**Engineering Review**

EPC Planning & Community  
Development Department

**FINAL DRAINAGE REPORT  
FOR  
HOMESTEAD NORTH AT STERLING RANCH FILING NO. 1  
EL PASO COUNTY, COLORADO**

**SF2213**

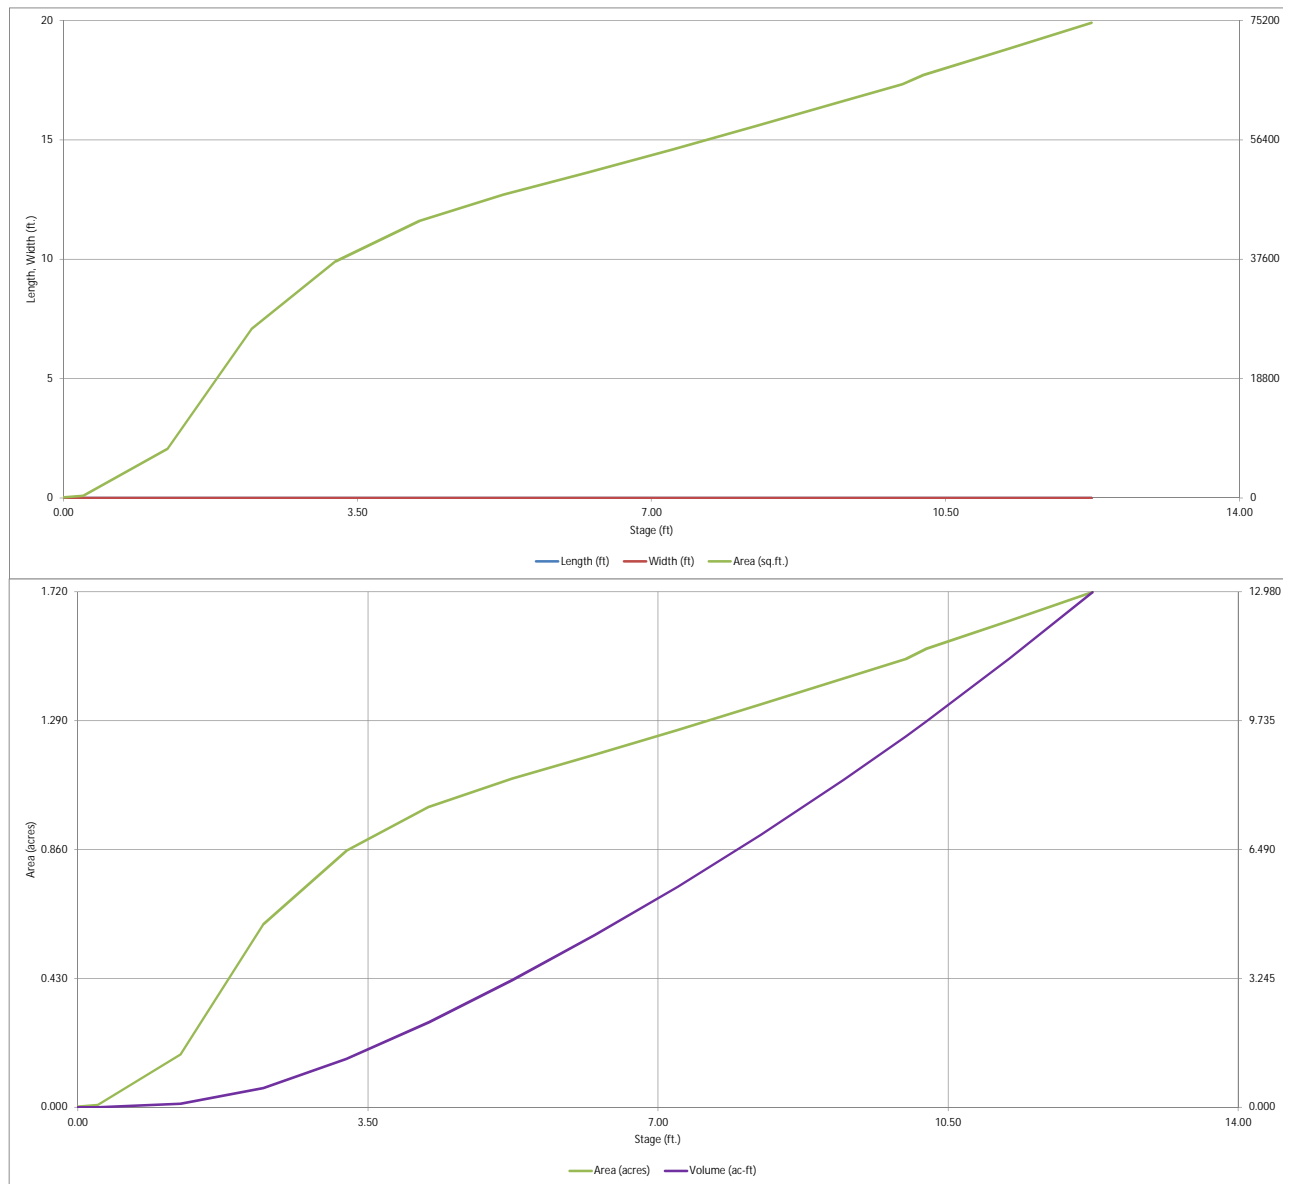
Provide calculations for the Type D inlets

EX DRAINAGE MAP  
HOMESTEAD NORTH  
JOB NO. 25188.00  
9-25-2021  
SHEET 1 OF 2

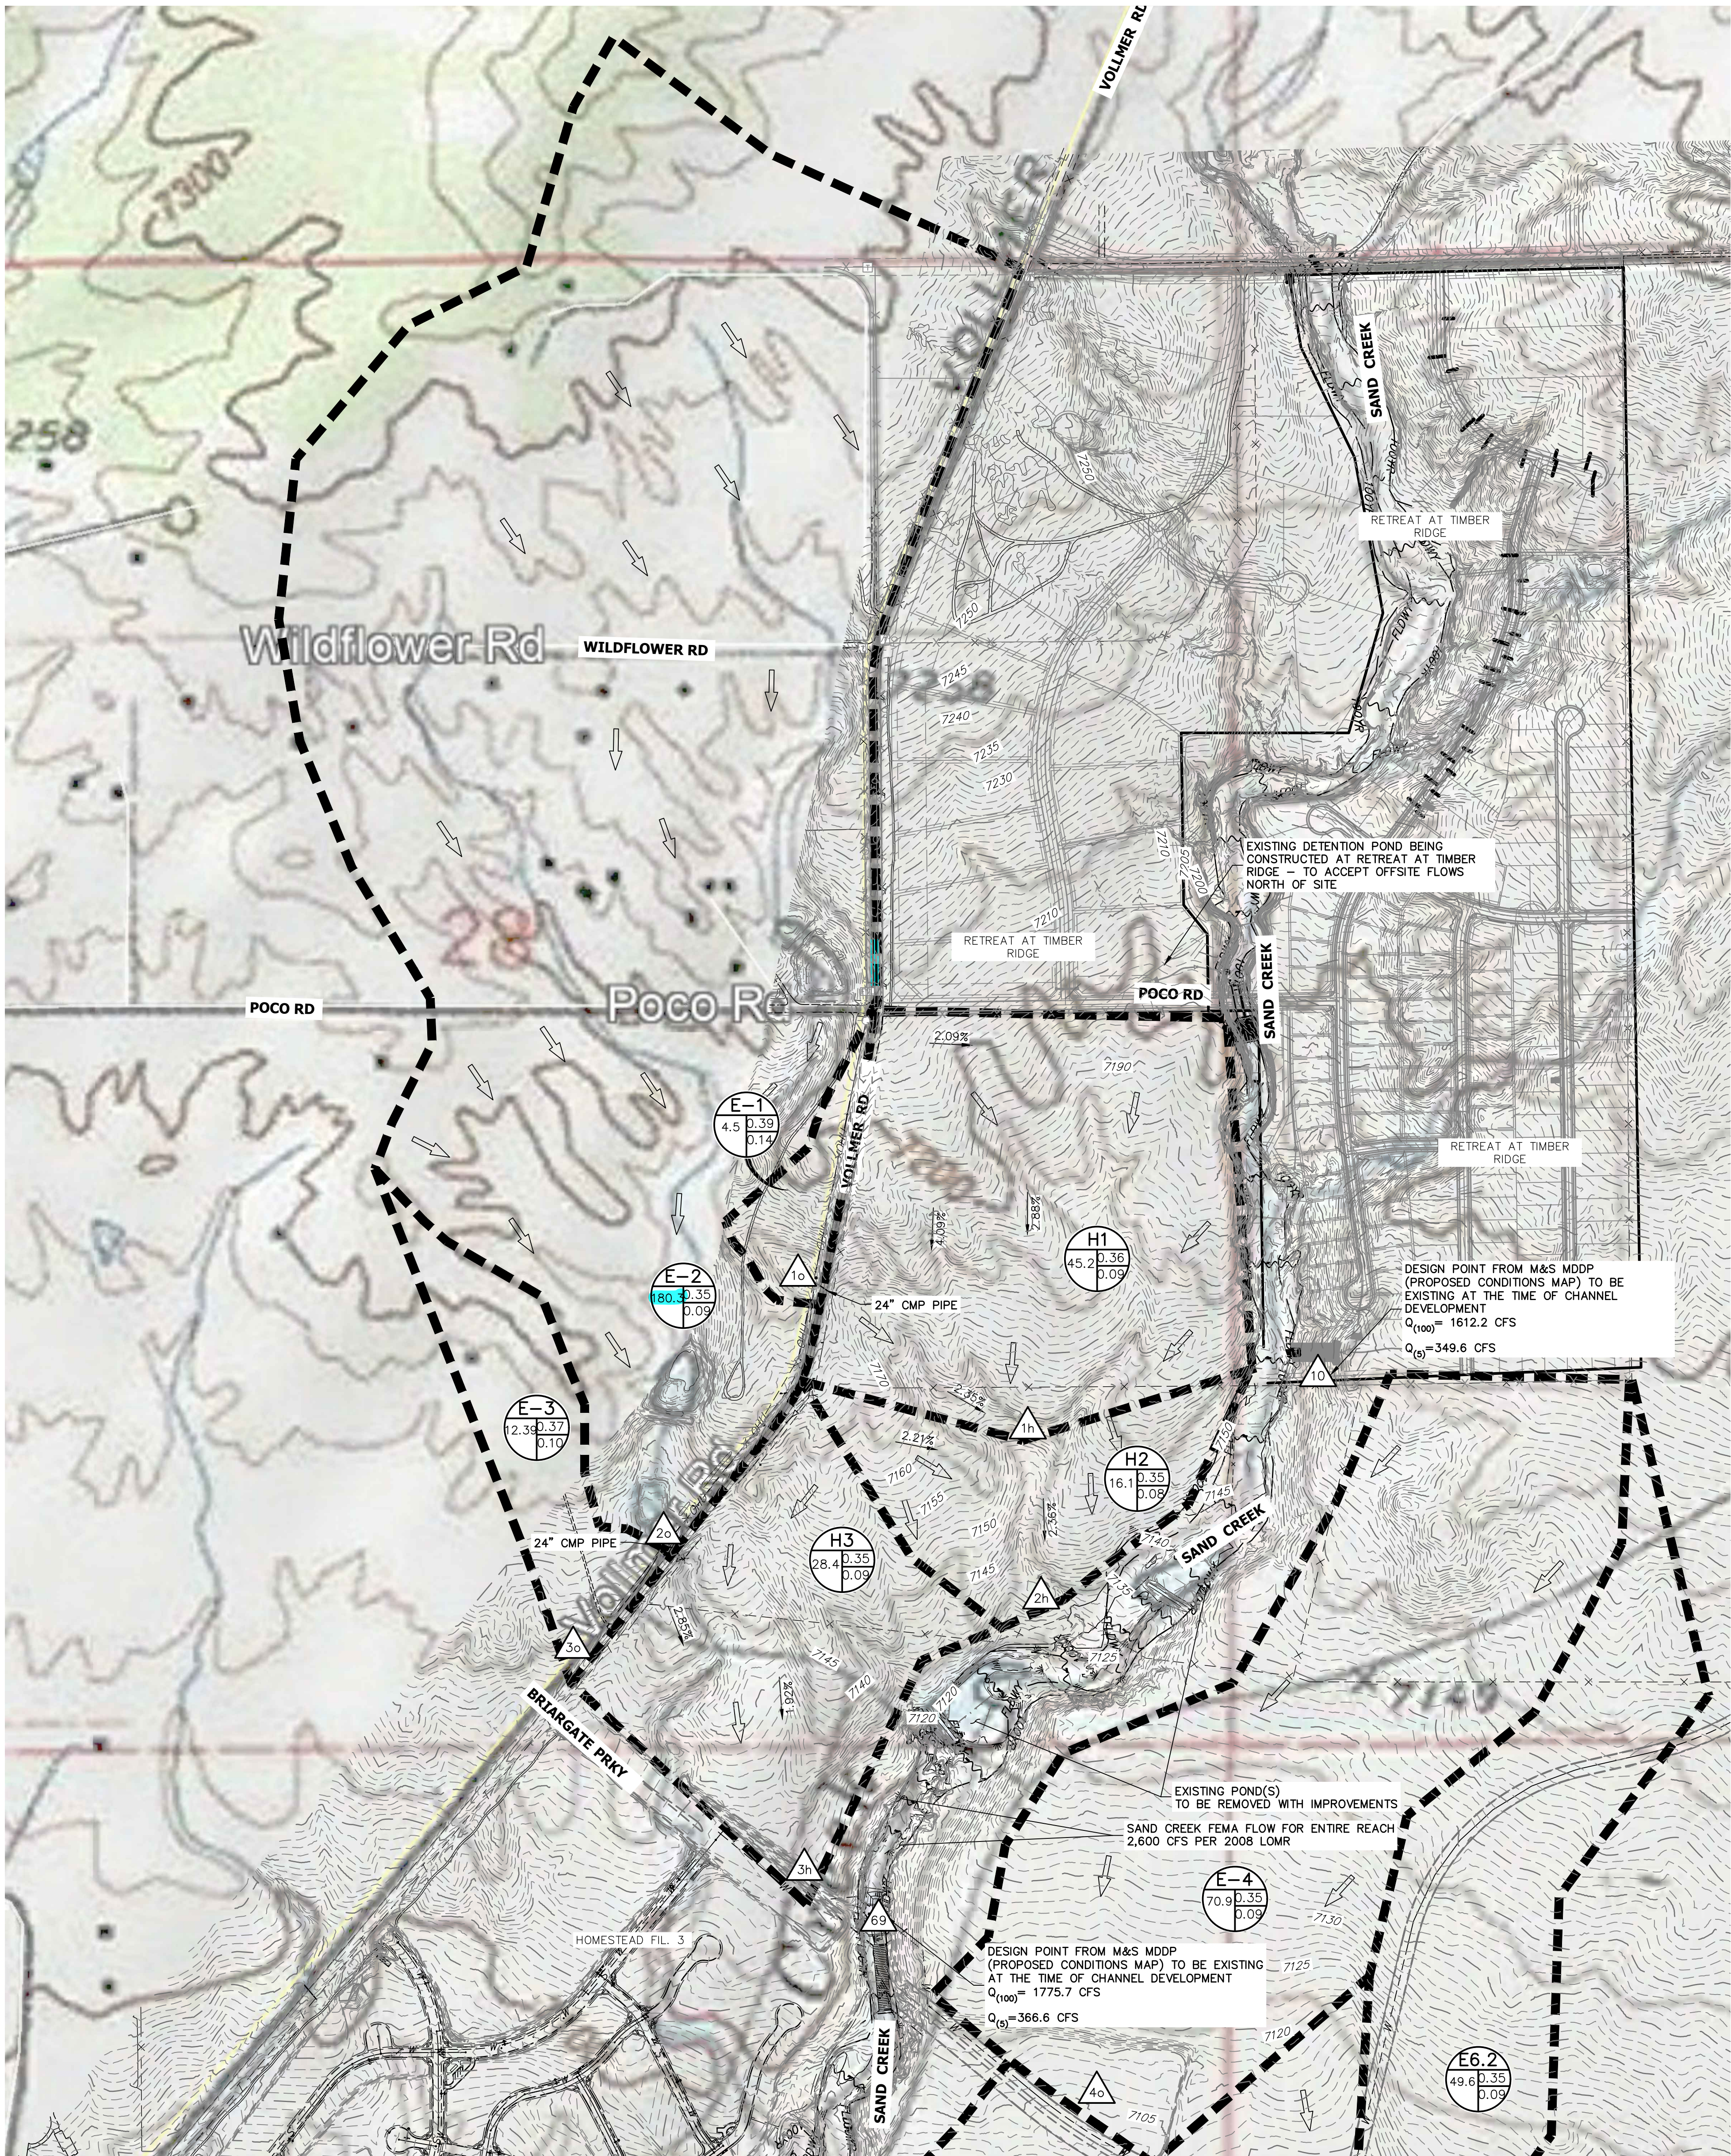
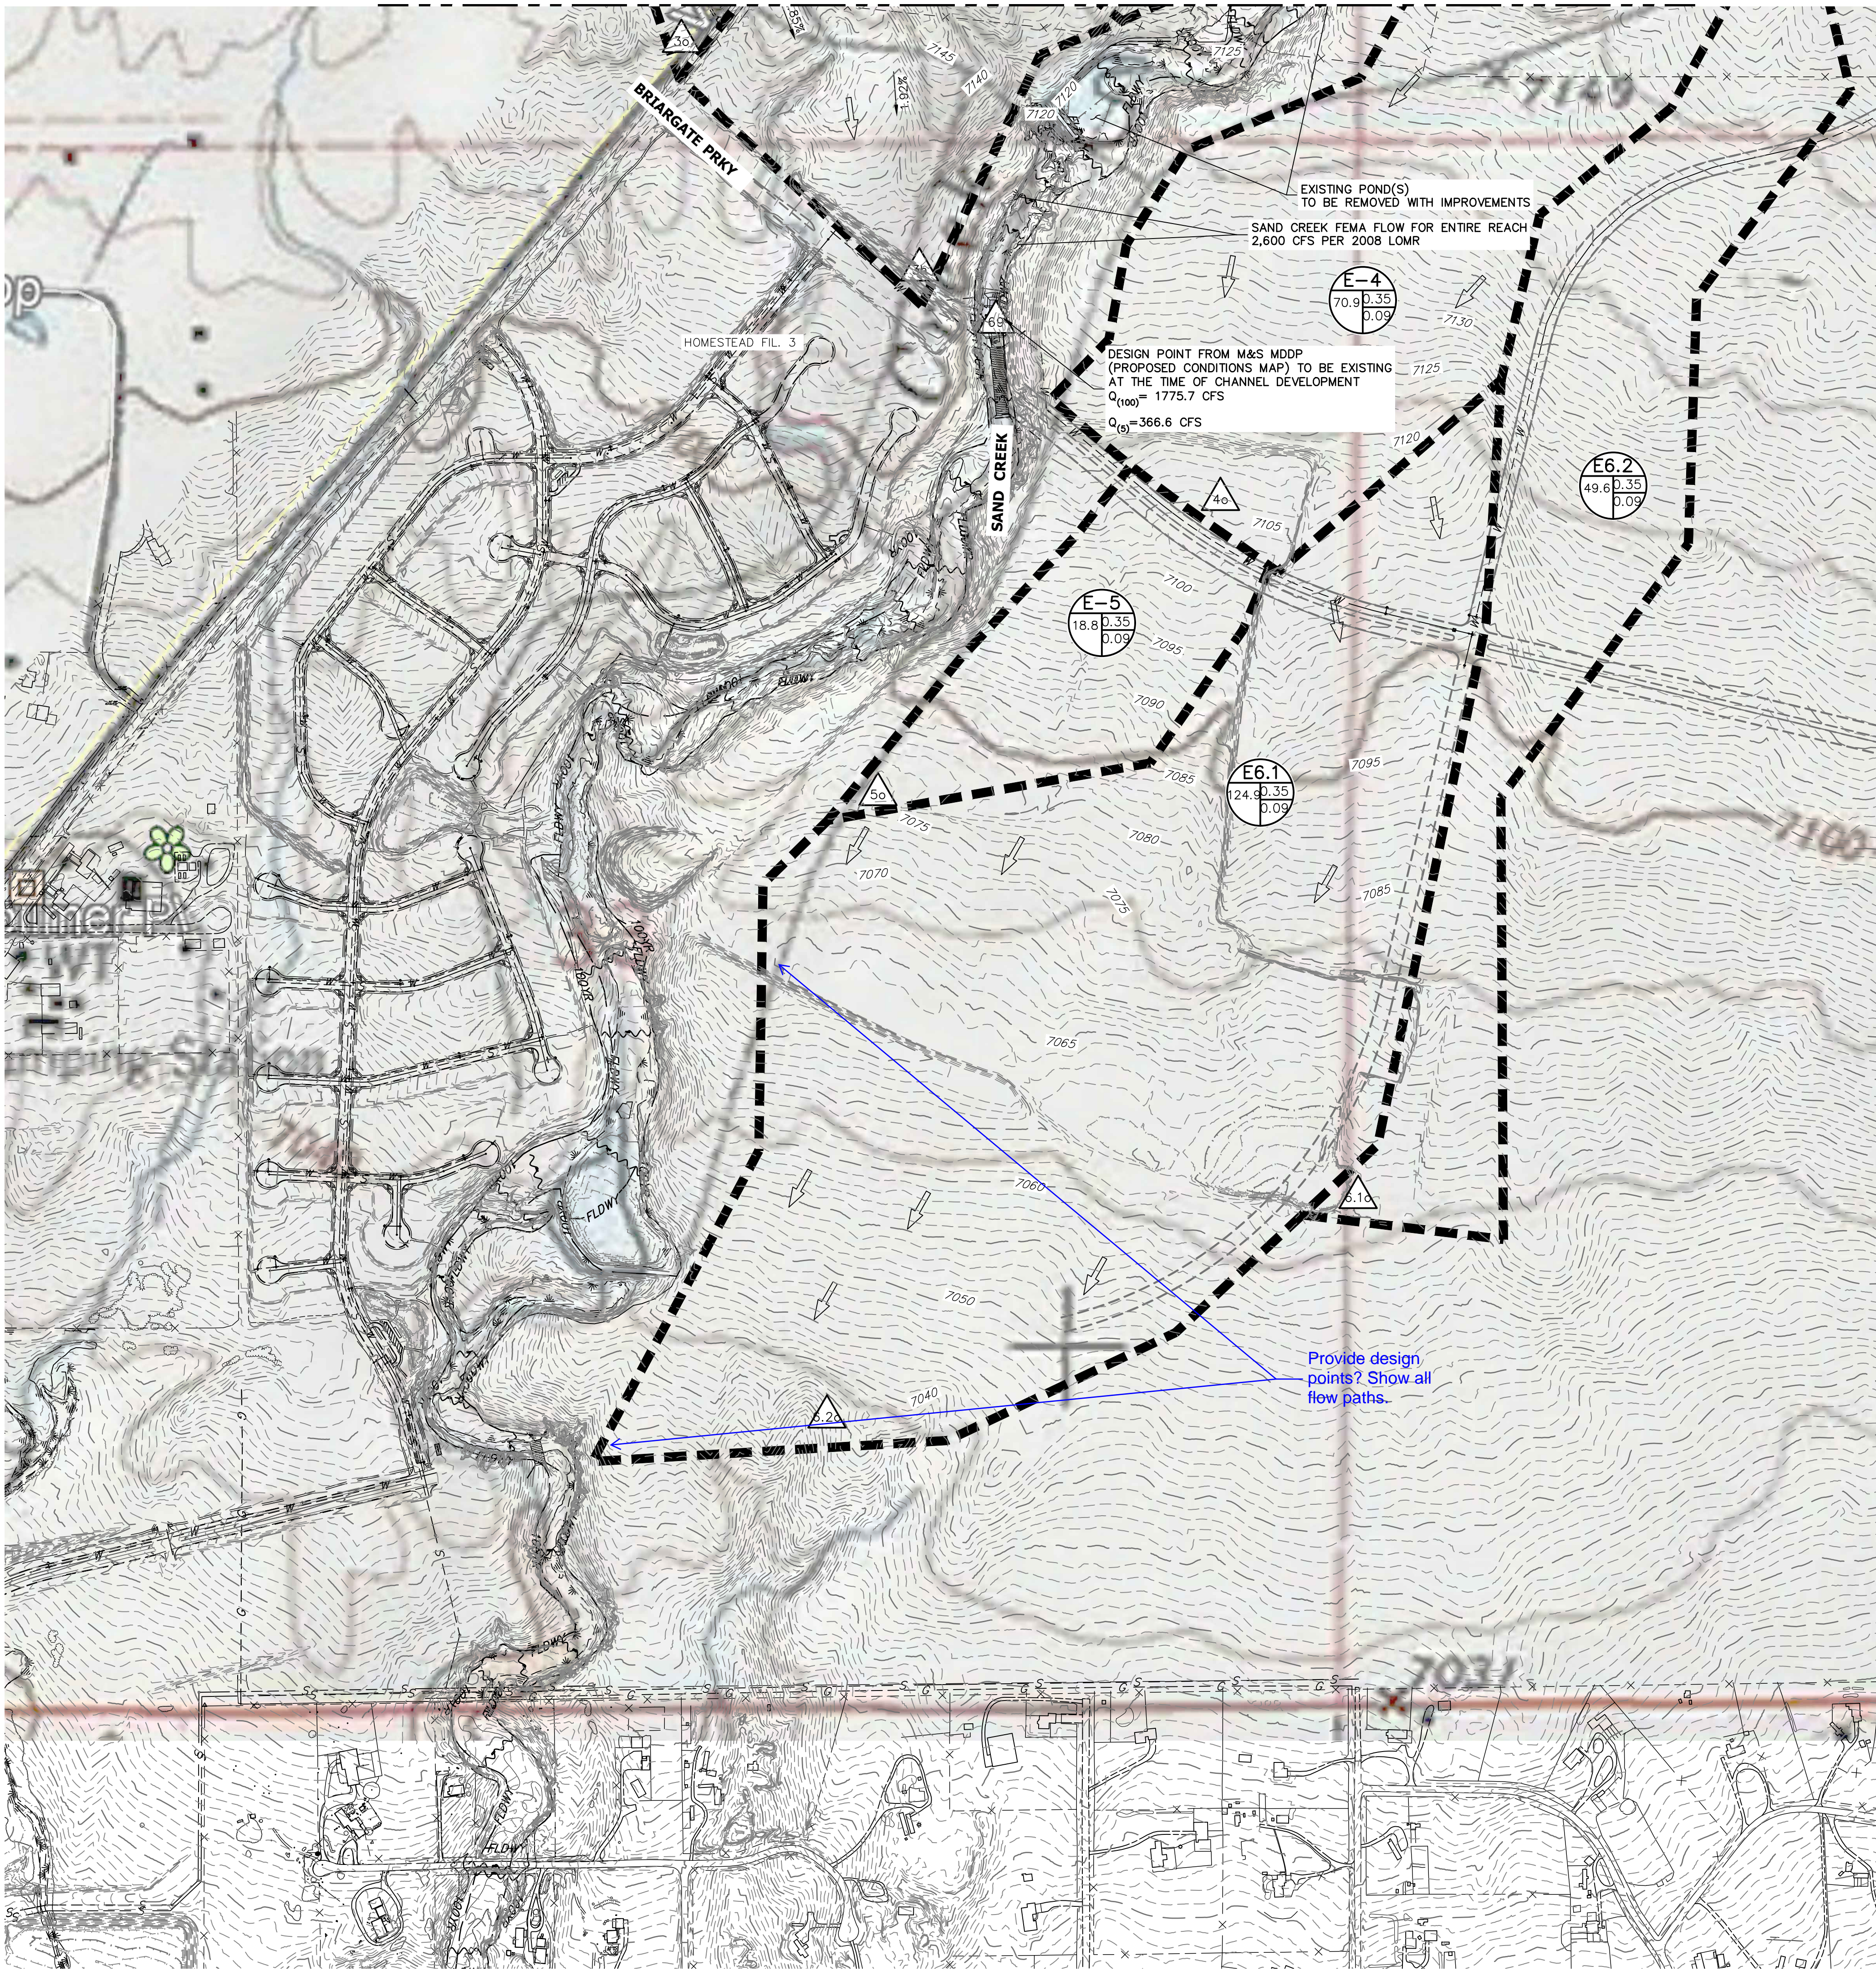
← Show on plan

↑  
highlighted values  
don't match  
drainage plan
